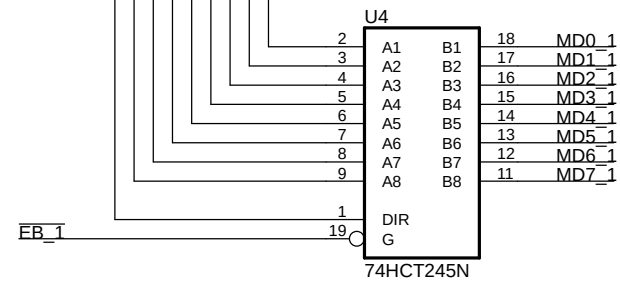
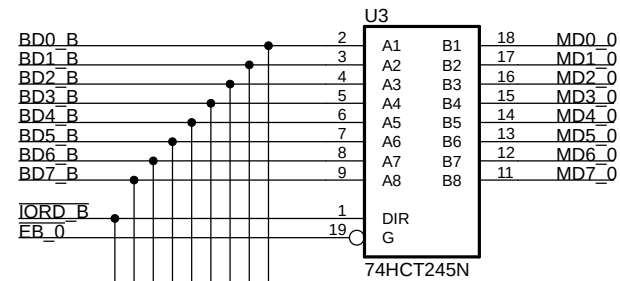
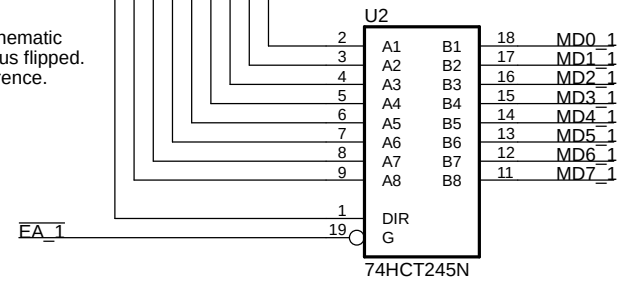
Note pin order in Intel Schematic on U2, U3 has the data bus flipped. Shouldn't make any difference.

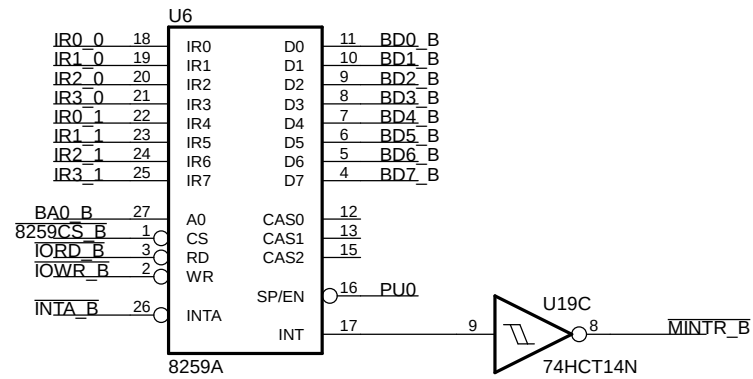
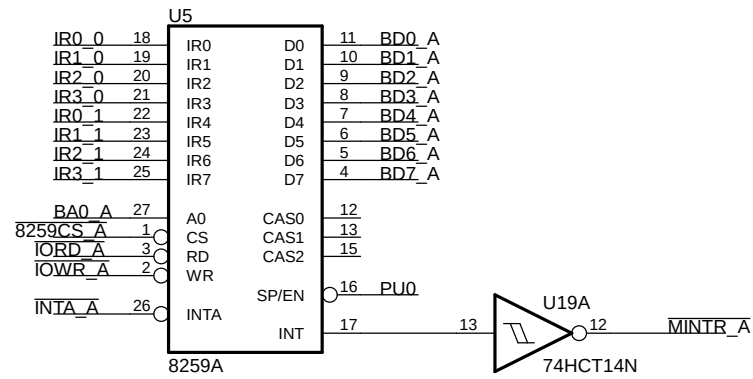
Note: Experienced issues here with the iPDS-100 locking up during boot. Removed U16, the 74LS51N. Suspect this may have been due to my using HCT for U18, the '00.

1. Leave U16 off, it's not necessary for SBX bubble memory, or
2. Consider using 74LS00 for U18 rather than 74HCT00, or
3. Consider adding pullups to U18 pins 1,2,4,5
